PIMA COUNTY
REGIONAL FLOOD CONTROL DISTRICT
97 EAST CONGRESS STREET, THIRD FLOOR
TUCSON, ARIZONA 85701-1797

**Re: Response to Incomplete and Incorrect Determination for Underground Storage Facility
Application No. 71-563876.0006**

We have reviewed your October 9, 2007 letter and have addressed the items you have listed:

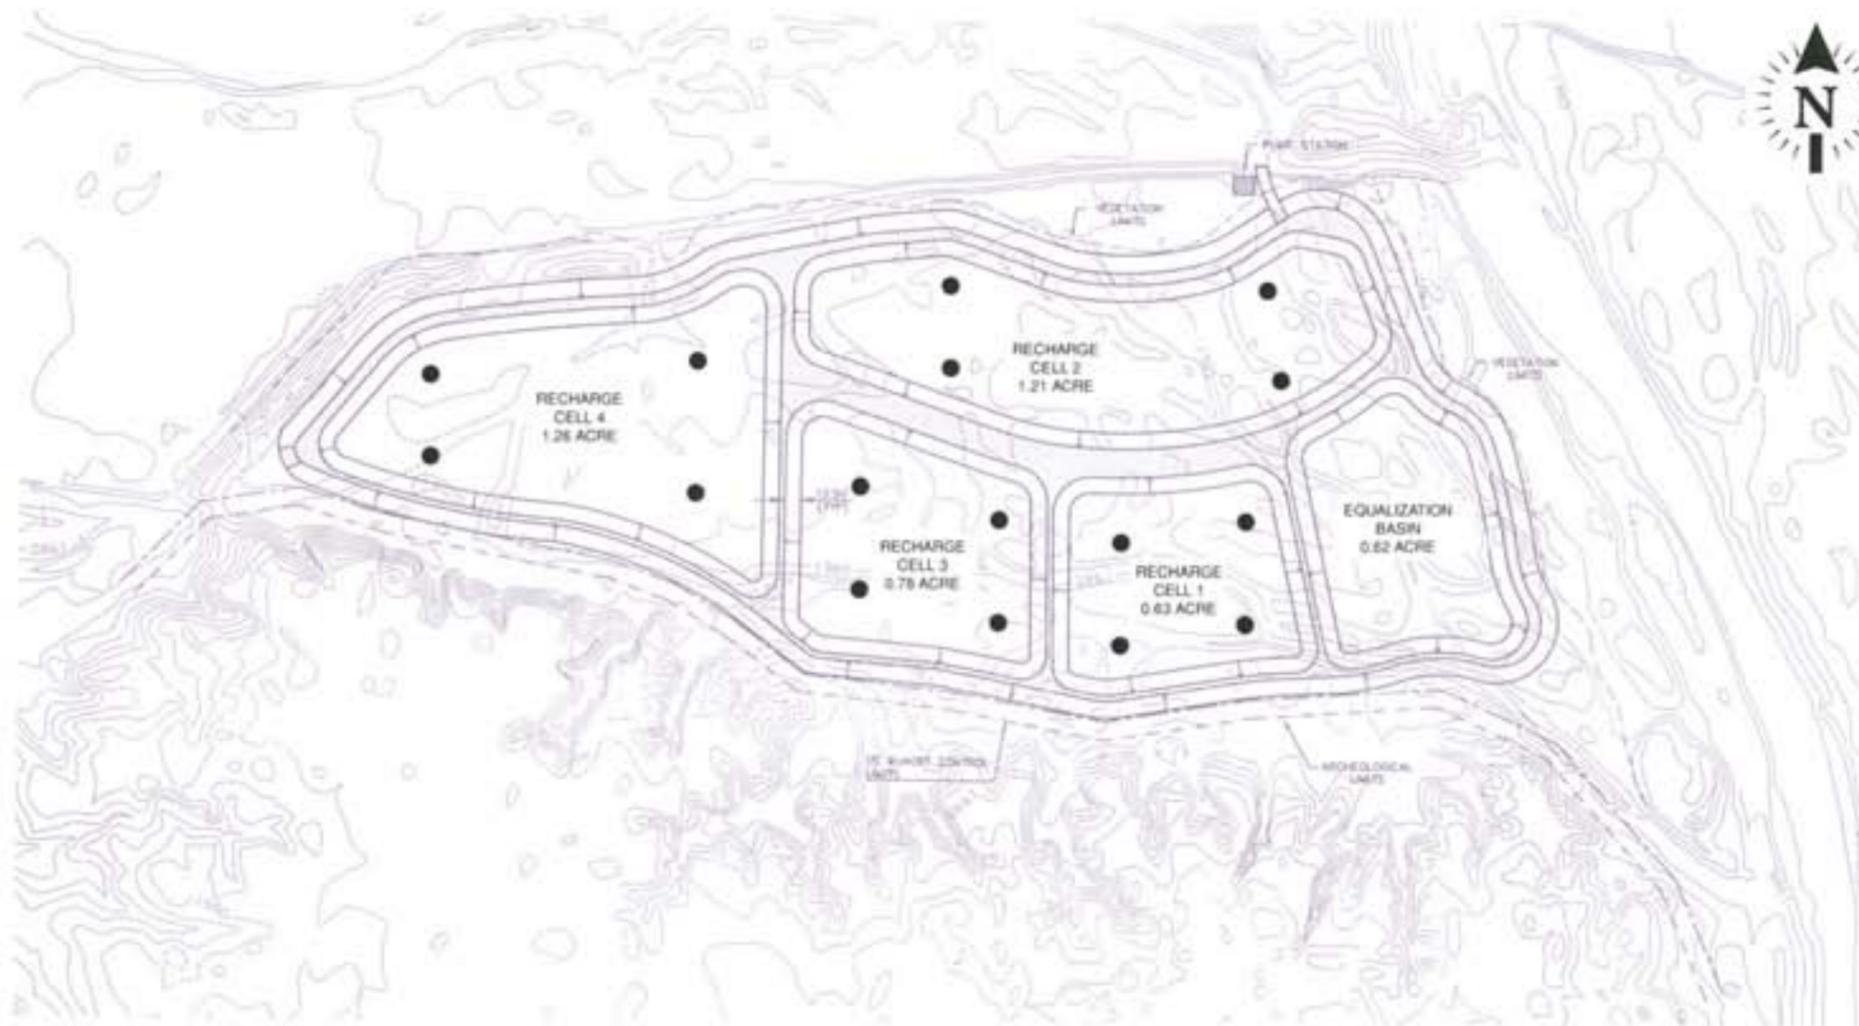
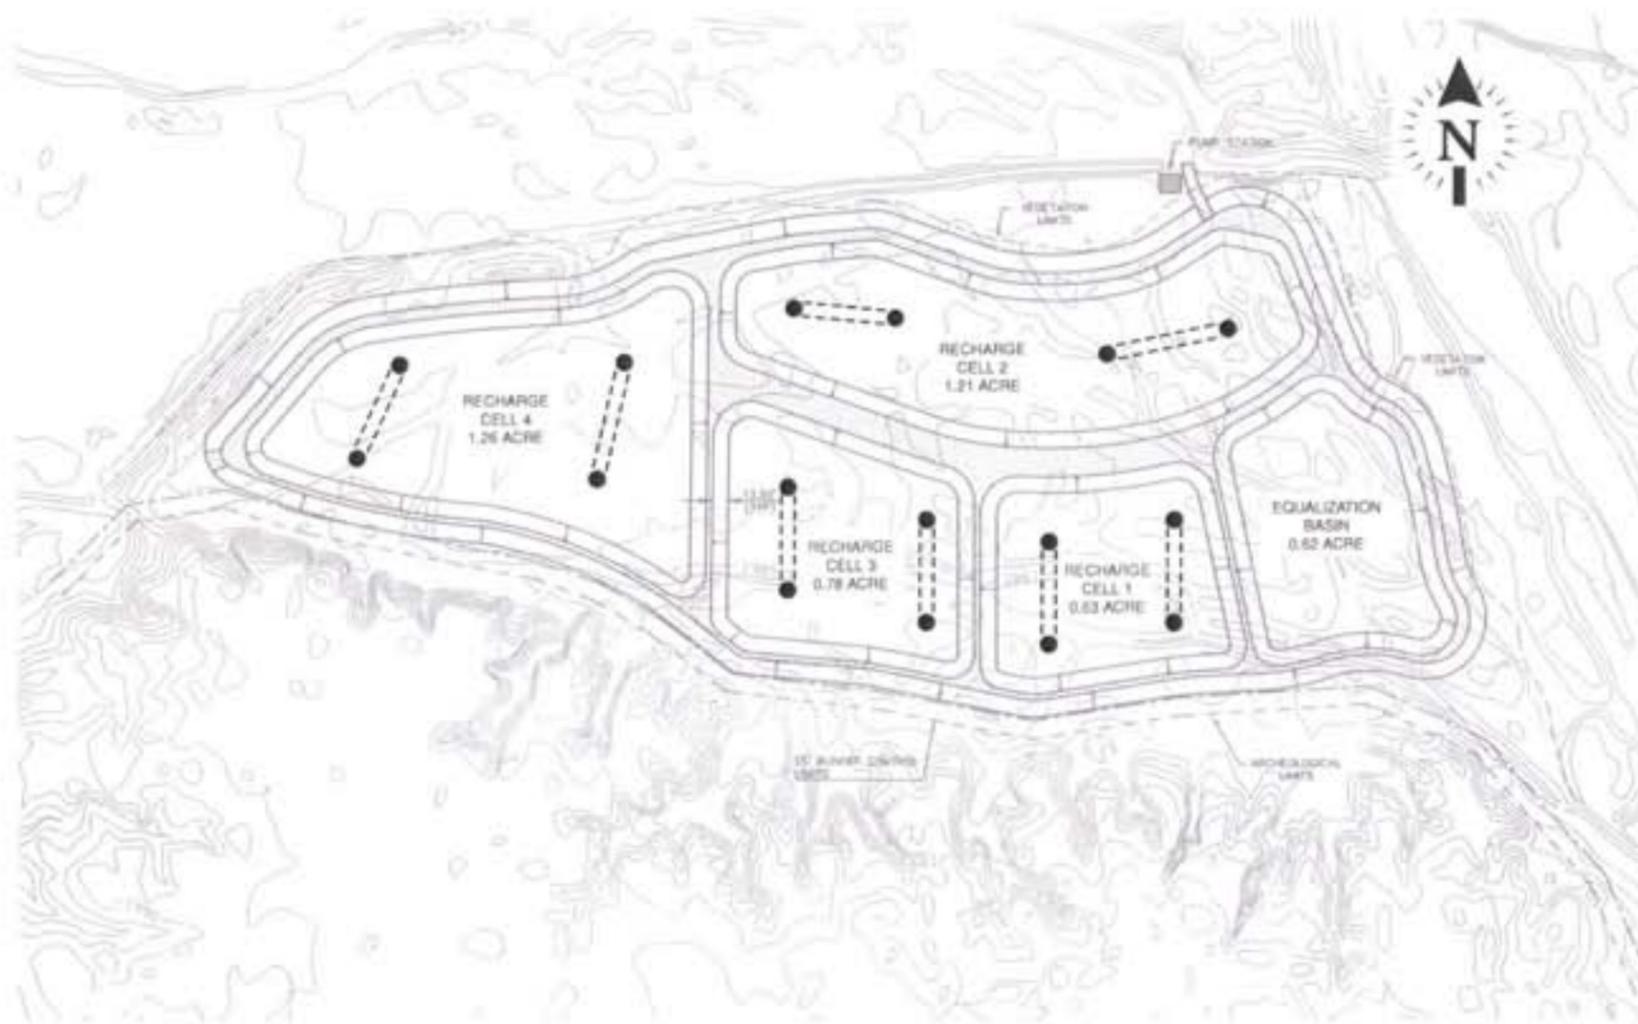
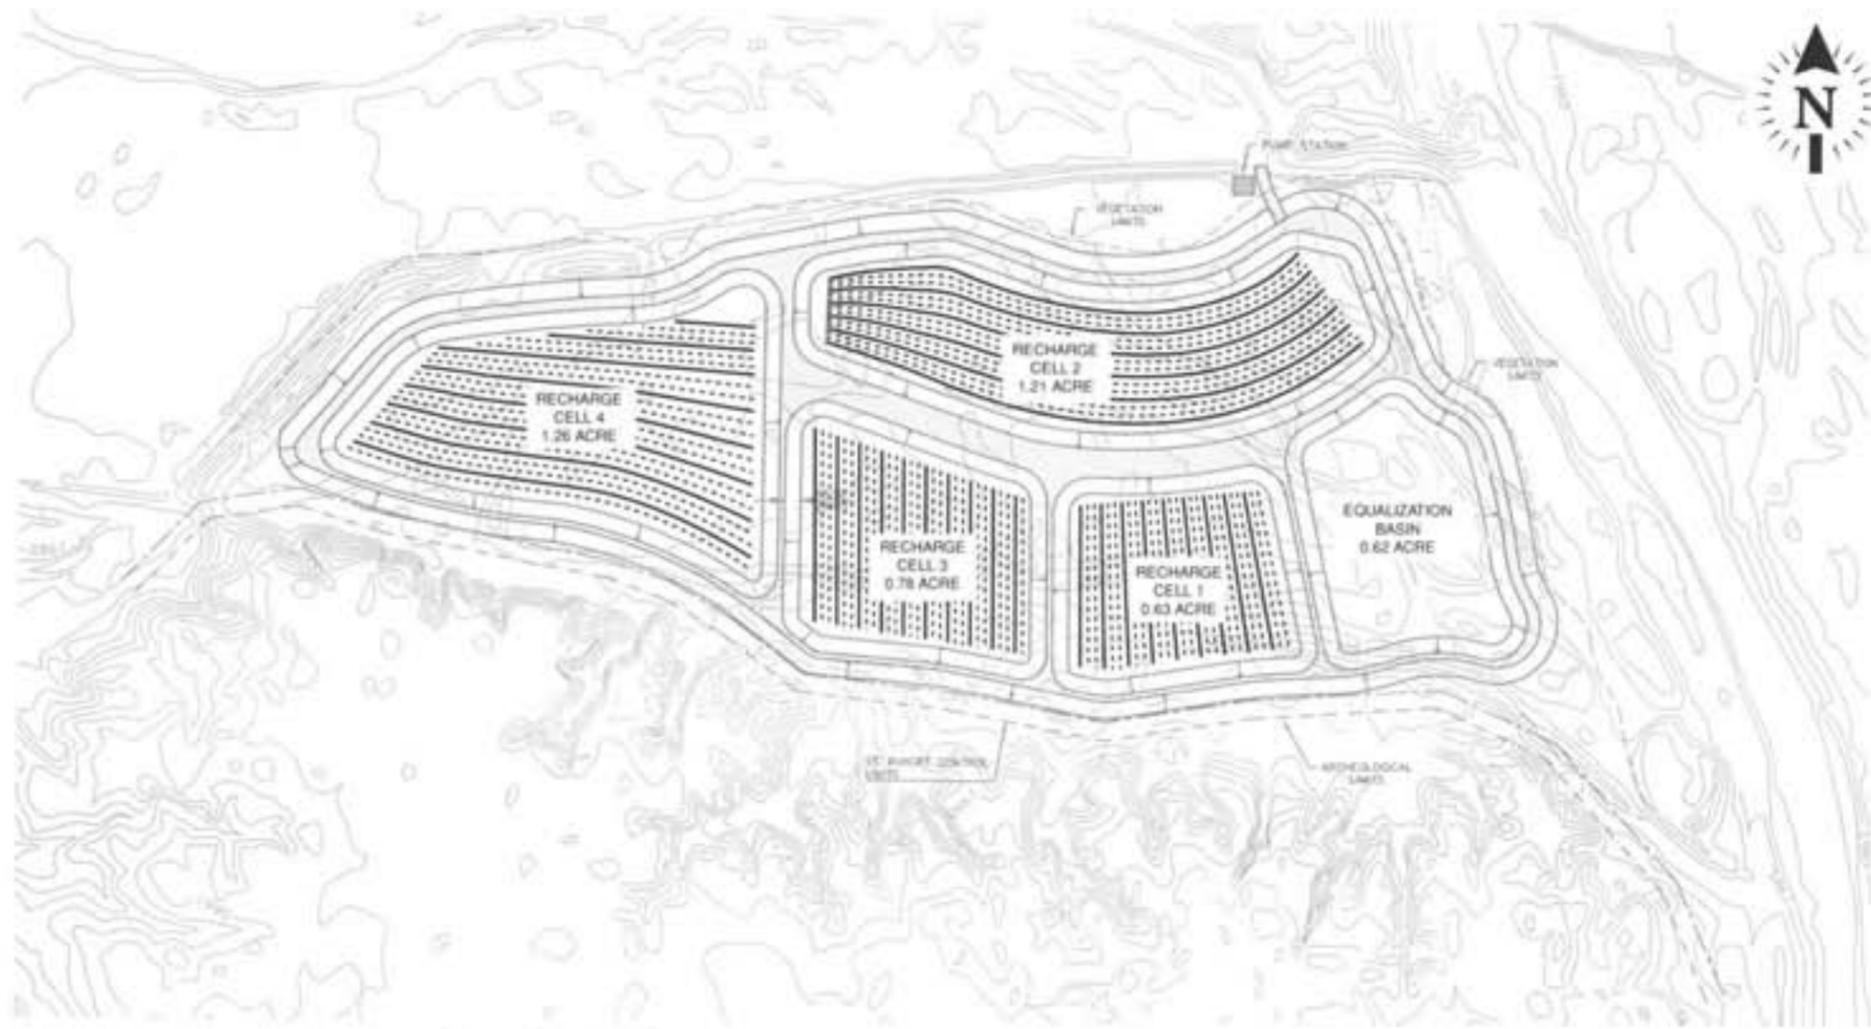
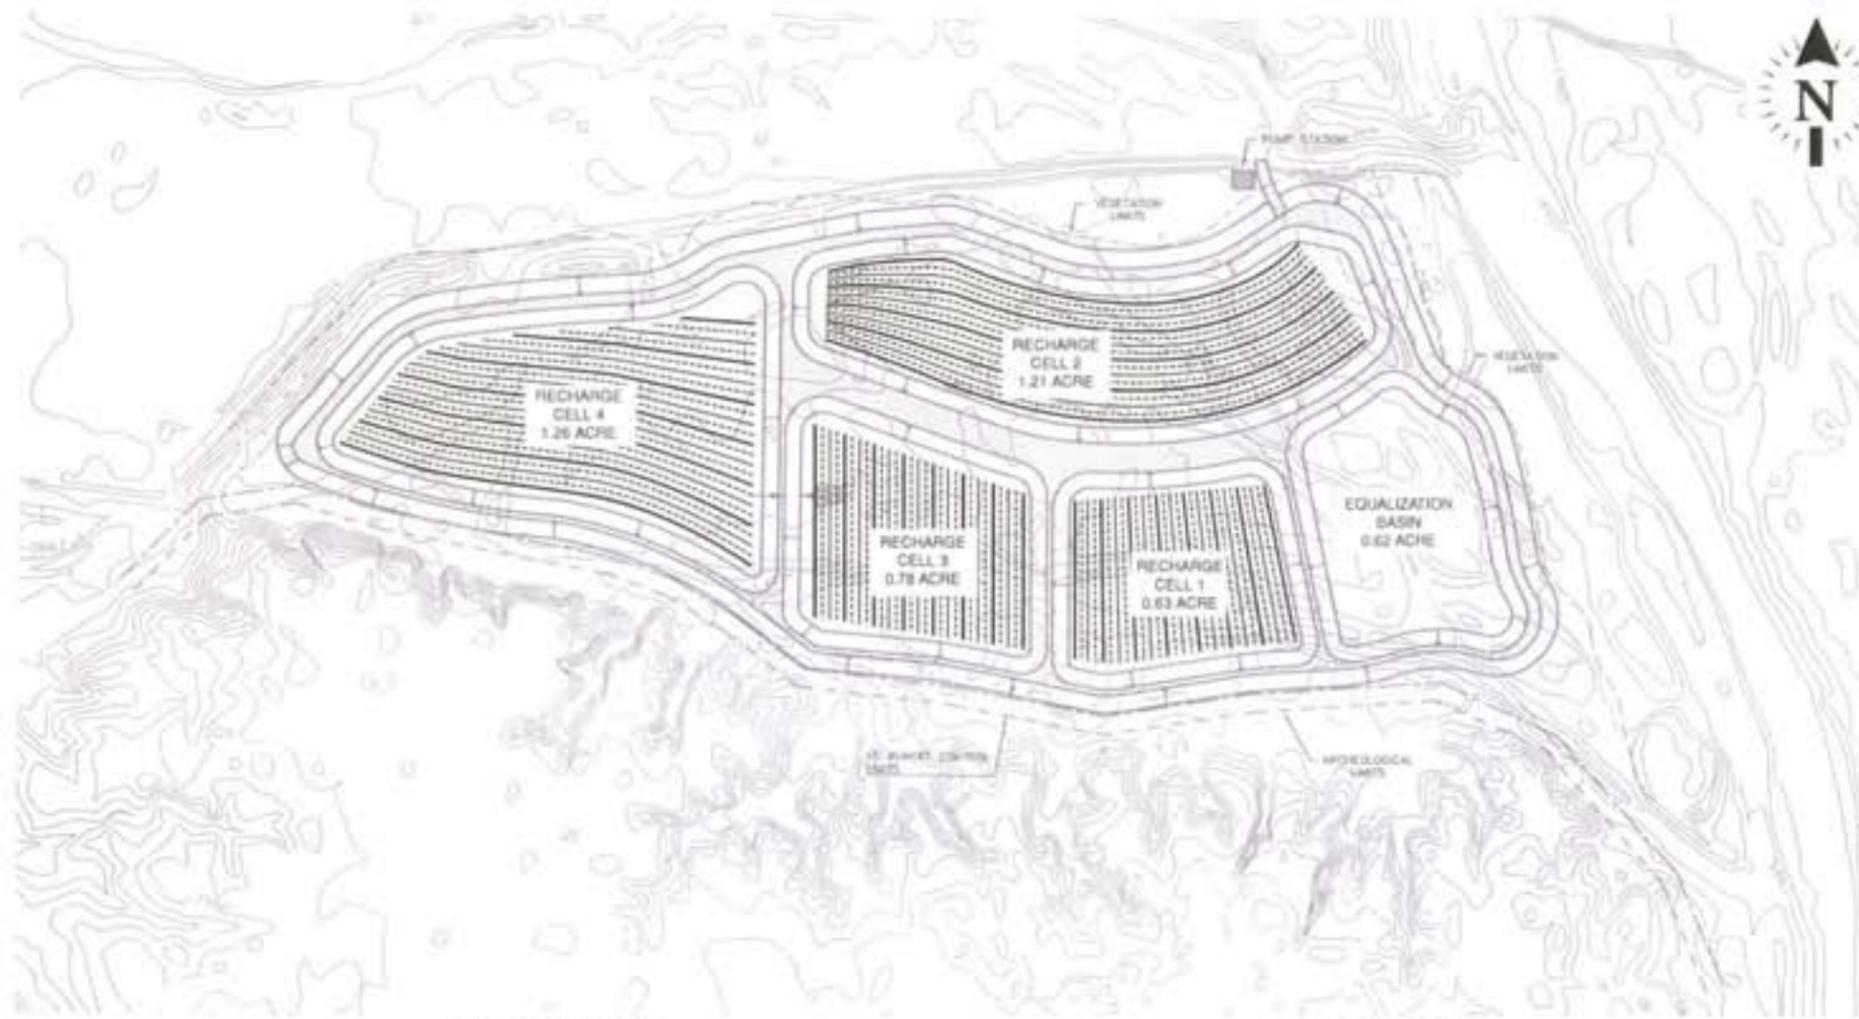
Bullet #5: A description of the proposed modified recharge basins is provided in Table 4 and shown in Figure 8. A description of the design contingencies (1 through 4) is provided in Table 4a, and maps of the design contingencies are provided in Figures 12a, 12b, 13a and 13b (**Attachment 6**). Different design contingencies or a combination of design contingencies may be used in each of the basins based on field investigations.

FIGURE 25. PROJECTED MAXIMUM AREA OF IMPACT AND GROUNDWATER LEVEL CHANGE RESULTING FROM EFFLUENT RECHARGE FROM JANUARY 1, 2003 THROUGH DECEMBER 31, 2022, WITHIN LOWER SANTA CRUZ RIVER MANAGED RECHARGE PROJECT (LSCMRP), PIMA COUNTY, ARIZONA

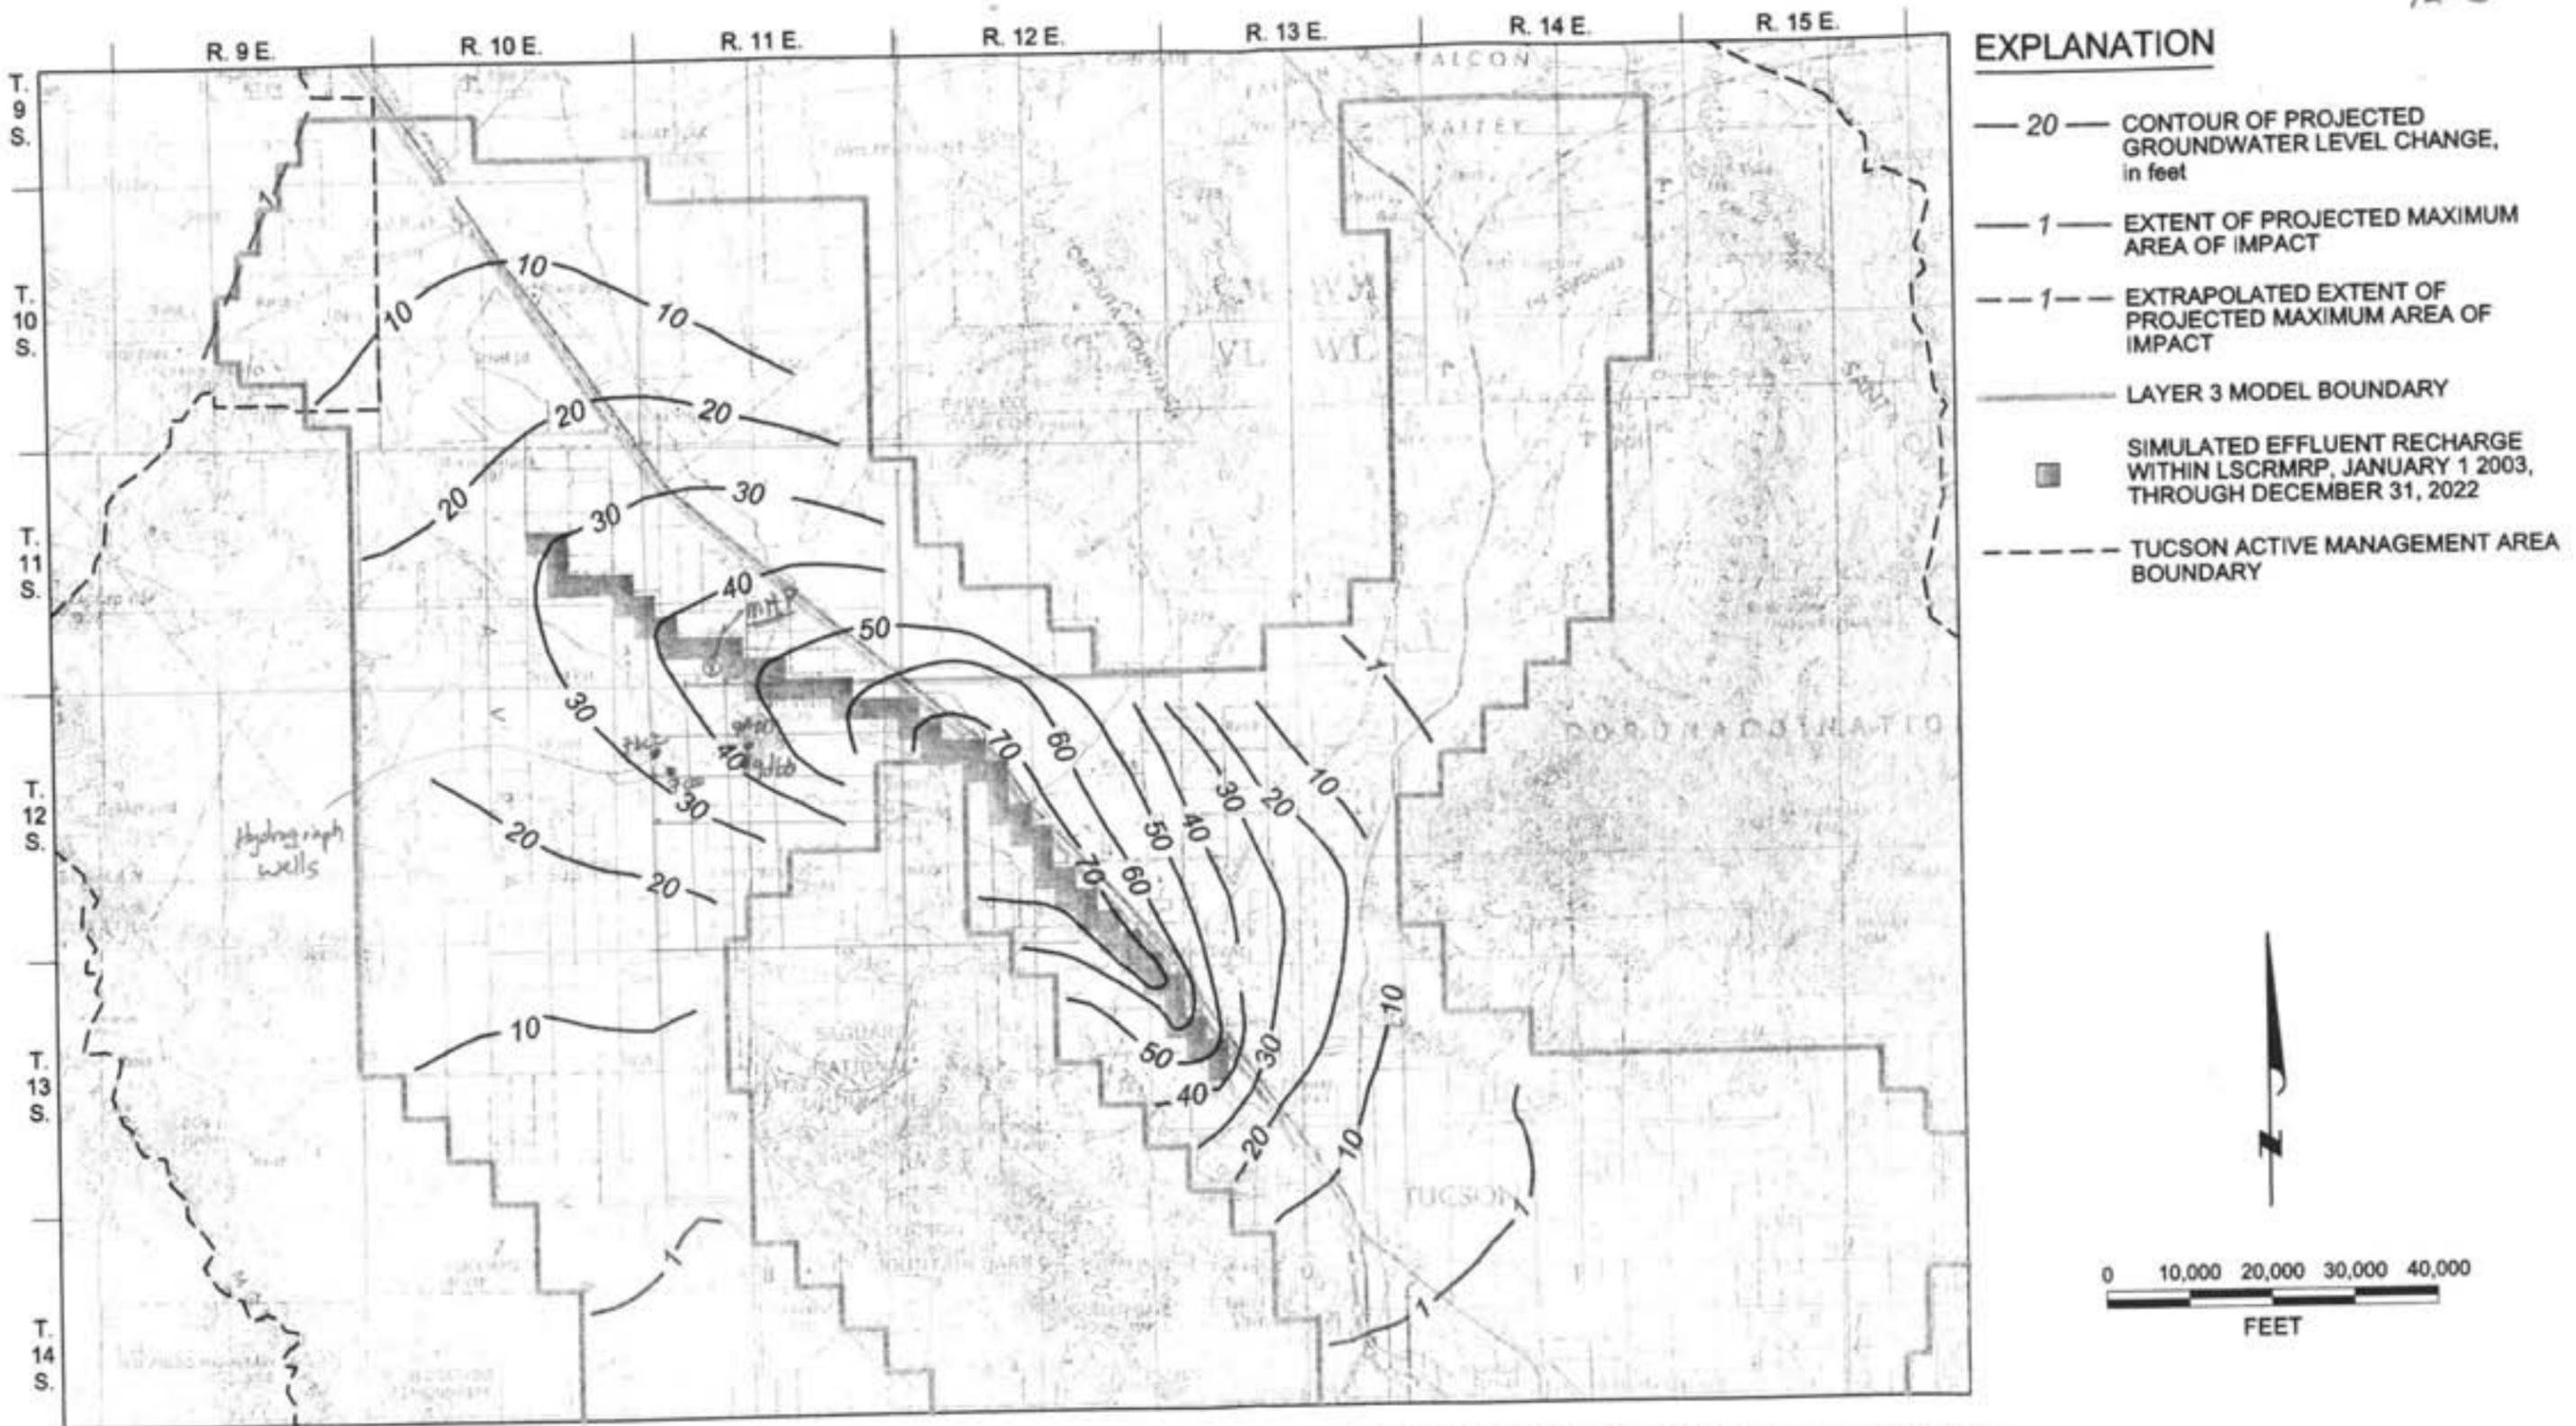
Montgomery's 2002b Modflow simulation of the LSCMRF showed an approximate water level recovery of 44 feet below the MHP site after 20 years (Attachment 12-3-Figure 25). Based on review of four hydrographs in the vicinity of the LSCRP and MHP Facility (Attachments 12-4-12-7) we were able to separate the regional water level recovery effects from the effects of the recharging effluent dominated Santa Cruz River before (1981-1995) permitting of the LSCMRF and from the prior regional recovery from the CAP recharge sites. That difference is shown in Table 1, and indicates a regional recovery trend over and above the Santa Cruz River effluent recharge contribution of approximately 0.55 ft/yr, or 11 feet in 20 years (Table 1).
